DEVELOPMENT ASSESSMENT REPORT	
Application No.	DA/2022/0120
Address	99 & 99A Louisa Road BIRCHGROVE
Proposal	Alterations and additions to the existing dwelling house, new garage with car stacker, swimming pool and roof terrace, and associated works at 99 Louisa Road, Birchgrove
Date of Lodgement	3 March 2022
Applicant	Benson McCormack Pty Ltd
Owner	Mrs Kristine L Jackson Mr Tibor PR Singer
Number of Submissions	Initial: Five (5) After Renotification: Two (2)
Value of works	\$850,000.00
Reason for determination at Planning Panel	Section 4.6 variation exceeds 10%
Main Issues	Site Coverage, Landscaped Area, FSR; Streetscape / Heritage, Parking; Solar Access, Views; and Privacy
Recommendation	Deferred commencement approval with Conditions
Attachment A	Recommended conditions of consent
Attachment B	Plans of proposed development
Attachment C	Section 4.6 Exception to Development Standards
Attachment D	Statement of Heritage Significance of Heritage Conservation Area

This report is an assessment of the application submitted to Council for alterations and additions to the existing dwelling house, new garage with car stacker, swimming pool and roof terrace, and associated works at 99 Louisa

Figure A - Existing views from No. 95 Louisa Road's Living room

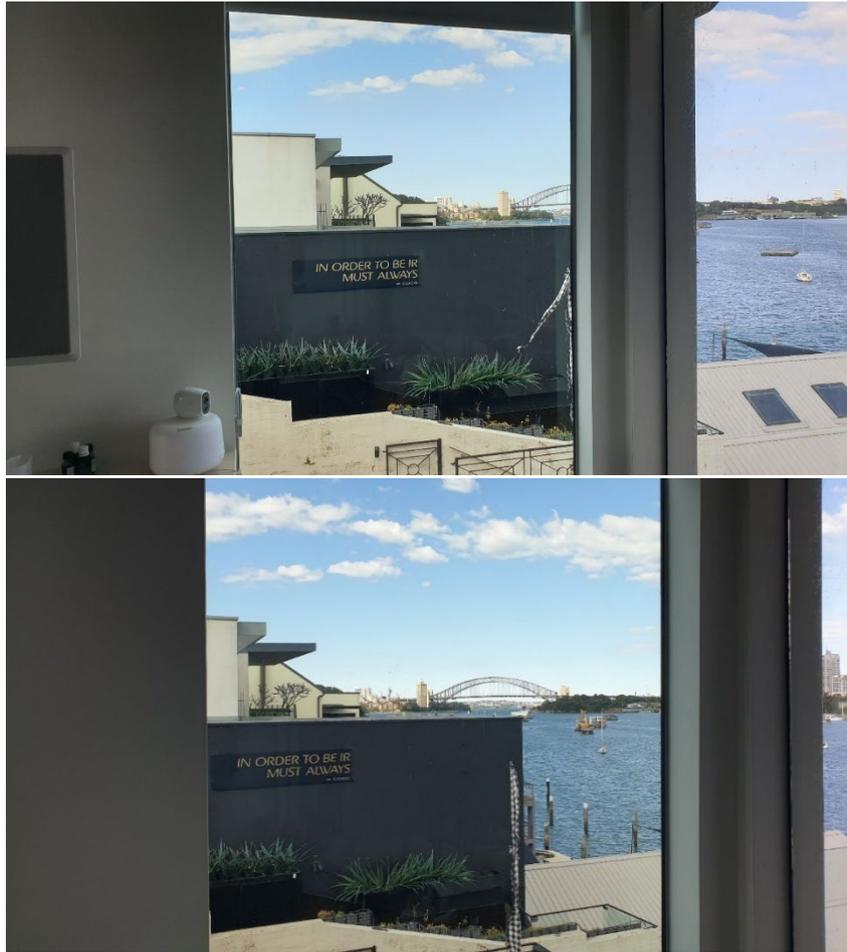
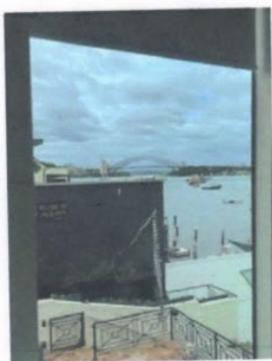
A submission was received regarding the neighbour's at 95 Louisa concerns of view loss of the Sydney Harbour Bridge and water views.

Council has considered the relevant steps in the assessment of reasonable view sharing. The images below indicate the existing views available from No. 95 Louisa Road's rear Balcony and the western window in the living. The below images were taken by Council during a site inspection of the property.

ORIGINAL PHOTO OF CURRENT VIEW FROM LIVING AREA OF 95 LOUISA ROAD

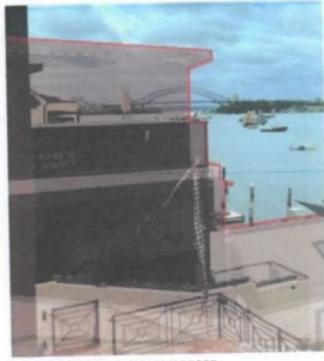
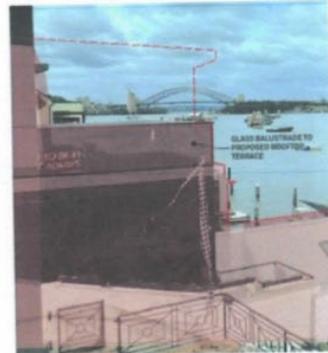
It was agreed between the parties that these view impacts would be fully ameliorated through specific design amendments to the design of upper storey including deletion of the pergola structure and blade privacy screen wall visible in the image below, and its replacement with a clear glass balustrade.

EXISTING BUILDING WITH PROPOSED DESIGN OVERLAYED

PROPOSED DESIGN WITH PRIVACY SCREEN AND PERGOLA STRUCTURE REMOVED (SHOWN DASHED), AS AGREED

The owner of 95 Louisa Road Birchgrove confirms that he does not object to the DA on the basis that Council allows the applicant to submit amended plans which reinstate and retain the existing views from 95 Louisa Road Birchgrove, as depicted above by making those amendments.

Original Development Application

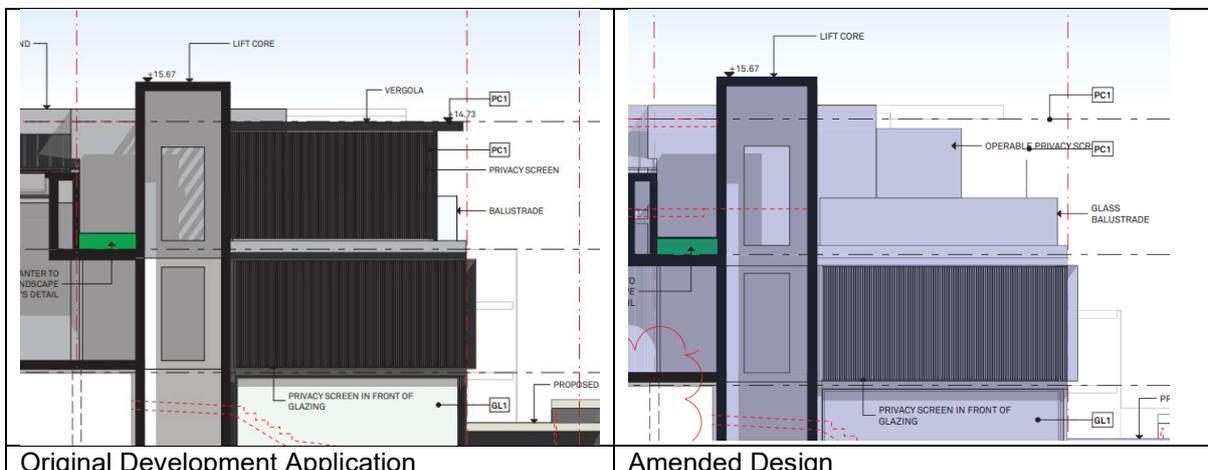
The amended proposal (refer to images below)-has removed the proposed privacy screen that is proposed to be erected on the western side of the roof terrace and replaced by a Glass Balustrade. Note that the operable privacy screen shown on the amended elevations is part of the proposed works at No. 99A Louisa Road (DA/2022/121) and does not form as part of this application.

It is noted that privacy screening was originally proposed on the western side of the proposed terrace, but was removed in the amended plans to address view loss concerns. While the proposed roof terrace will result in additional sightlines to 97 and 99A Louisa Road, there are already existing sightlines into their private open spaces from the first floor balconies of 95 and 101 Louisa Road respectively.
